Range Inspection Checklist Cover Sheet

Name of range: **SA Police Academy**

Date inspected: 10 October 2023

Pistol & Shotgun – law enforcement training

1.4 Multiple exit points through metal cladding and ventilation mesh. Note marking on ceiling from repeated strikes.

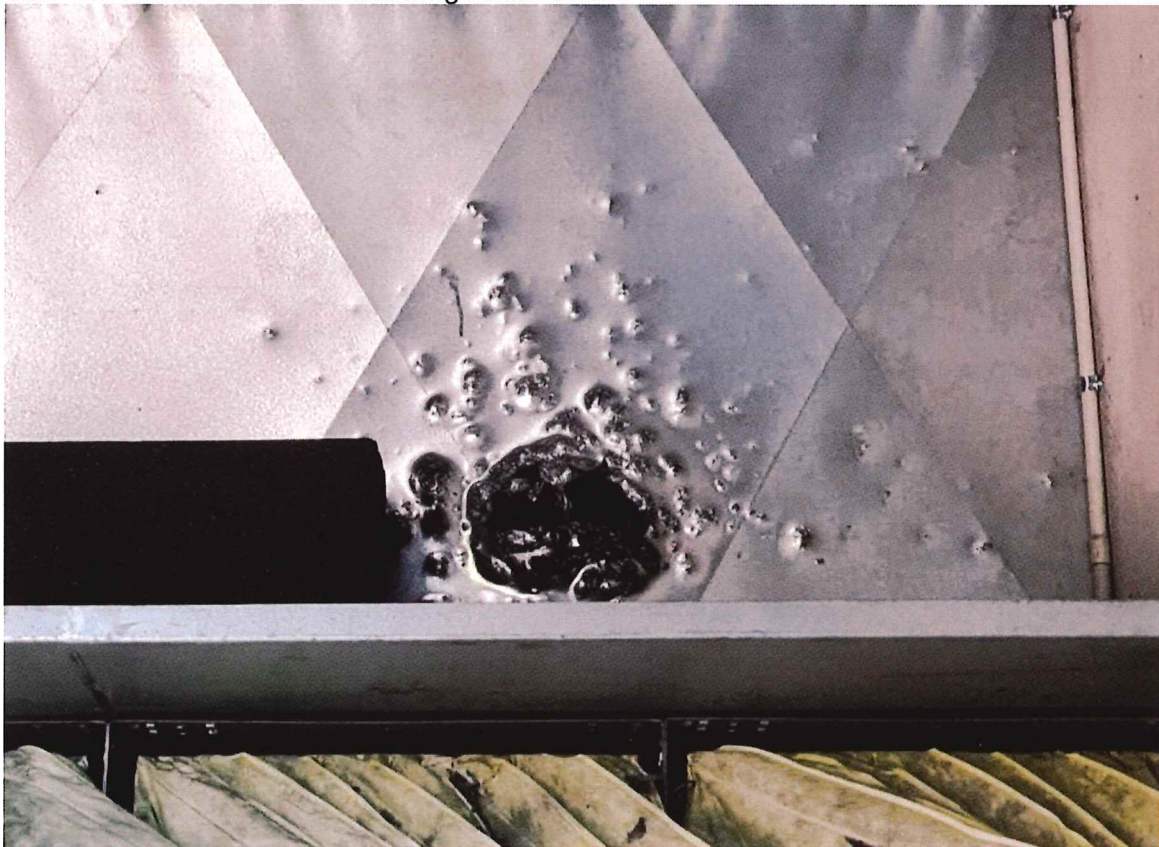
1.5 Ventilation mesh damaged by projectiles. Burn marks and holes clearly visible.

1.6 Hole in metal cladding above ventilation padding. Black ballistic block was put in place once issue was discovered and range was closed.

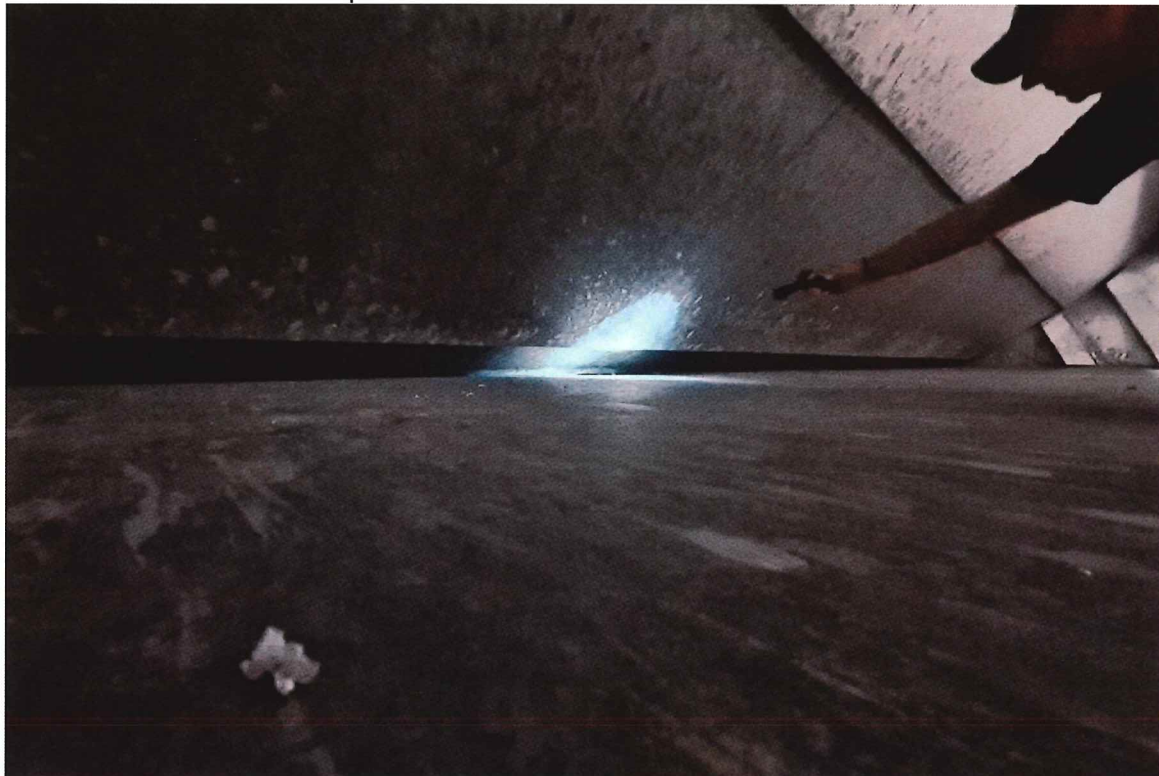
1.7 Damage caused to wall directly across from exit hole. Most recent damage was caused yesterday prior to range closure.
